Access Compliance Report

Public Rights-of-Way

(Curb Ramps)

Intersection ID: 53713	Main Street: N_TRYON_ST	Cross Street: PERIWINKLE_HILL_AV	Location: NW
ADA ID: 0AD3EF11745A	Ramp Type: Perp	Initial Pass/Fail: Fail	Overall Compliance: No
Codes/Mitigation Info/Possible Solution		Field Measurements/Component Compliance	
Severity Score: 8.75

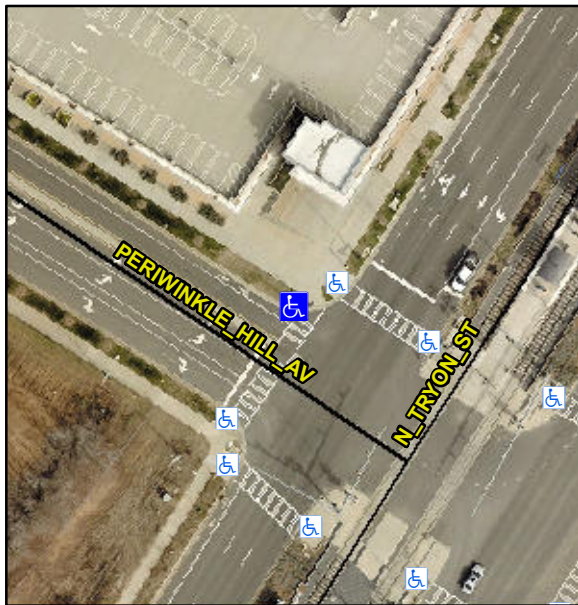
Not Found, R304.5.1

Compliance	Description	Data	Compliance	Description	Data
N/A	Ramp Length (in)	95.0	Yes	Ramp Slope (%)	5.3
No	Ramp Width (in)	47.0	Yes	Ramp XSlope (%)	0.2
N/A	Flare Type LT	N/A	N/A	Flare Type RT	N/A
N/A	Flare Slope LT (%)	N/A	N/A	Flare Slope RT (%)	N/A
N/A	Flare Traversable LT?	N/A	N/A	Flare Traversable RT?	N/A
N/A	Landing Length (in)	N/A	N/A	DWS Provided?	N/A
N/A	Landing Width (in)	N/A	N/A	DWS Contrast?	N/A
N/A	Landing Slope (%)	N/A	N/A	DWS Length (in)	N/A
N/A	Landing X Slope (%)	N/A	N/A	DWS Full Width?	N/A
N/A	Landing Curb? (Y/N)	N/A	N/A	DWS Offset (in)	N/A
N/A	Shared Landing?	N/A			
N/A	Gutter Ponding?	N/A	N/A	Gutter Slope (%)	N/A
N/A	Gutter Lip Ht (in)	N/A	N/A	Gutter X Slope (%)	N/A
N/A	Painted X Walk1?	Yes	N/A	Painted X Walk2?	N/A
	X Walk 1 Direction	To SW		X Walk 2 Direction	N/A
N/A	X Walk 1 Width (in)	117.0	N/A	X Walk 2 Width (in)	N/A
	X Walk 1 Slope (%)	1.7		X Walk 2 Slope (%)	N/A
	X Walk 1 X Slope (%)	2.8		X Walk 2 X Slope (%)	N/A

N/A	Ramp inside XWalk1?	Yes	N/A	Ramp inside XWalk2?	N/A
	Road Slope (%)	N/A	N/A	Clear Space?	N/A
	Road X Slope (%)	N/A	N/A	Clear Space to XWalk (in)	N/A
N/A	Any Obstructions?	N/A	N/A	Storm Grate/Utility Hazard?	N/A
	Obstruction Type			Storm Grate/Utility Type	
		N/A			N/A
		Yes		Surface Condition? (G/P)	Good

Remove & Replace Entire Ramp.
